Subject: MHI's Response to US-APWR DCD RAI No. 107

Reference: 1) "Request for Additional Information No. 107-1293 Revision 0, SRP Section: 03.09.04 – Control Rod Drive Systems, Application Section: 3.9.4," dated 11/24/2008

Response to Request for Additional Information No. 107-1293,
Revision 0

RAI NO.: NO. 107-1293 REVISION 0
SRP SECTION: 03.09.04 -- CONTROL ROD DRIVE SYSTEMS
APPLICATION SECTION: 3.9.4
DATE OF RAI ISSUE: 11/24/08

Figure 1 Applied Area of the Chrome Carbide Coating

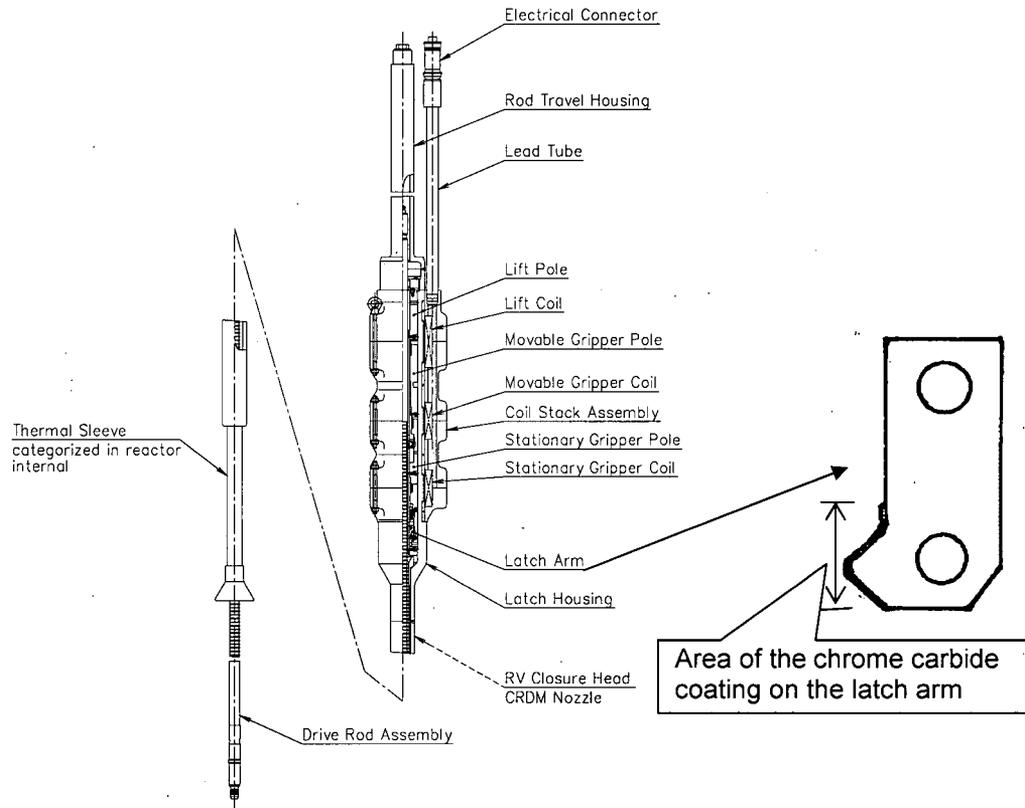
- a. Describe differences between the US-APWR and the previous design, such as the L-106A CRDM and discuss their effects on the applicability of the previous operability tests to the US-APWR CRDM. US-APWR DCD Tier 2, Section 3.9.4.1.1 (page 3.9-56) states that the US-APWR CRDM design is improved by (1) butt welding the CRDM latch housing to the CRDM nozzle on the reactor vessel closure head and (2) applying a chrome carbide coating to the latch arms.

The design of the US-APWR CRDM latch assembly is the same as the previous L-106A type CRDM, except the chrome carbide coating on the latch arms to improve wear resistance. The latch assembly is shown in Figure 1. This design change does not affect operability, since the thickness of the chrome carbide coating is thin enough compared with the clearance between the latch tip and the groove of the drive rod.

Thickness of the chrome carbide coating on the latch arm is [] mils, which is thin enough compared with the approximately [] inch clearance between the latch tip and groove of the drive rod. Therefore, chrome carbide coating does not affect operability.
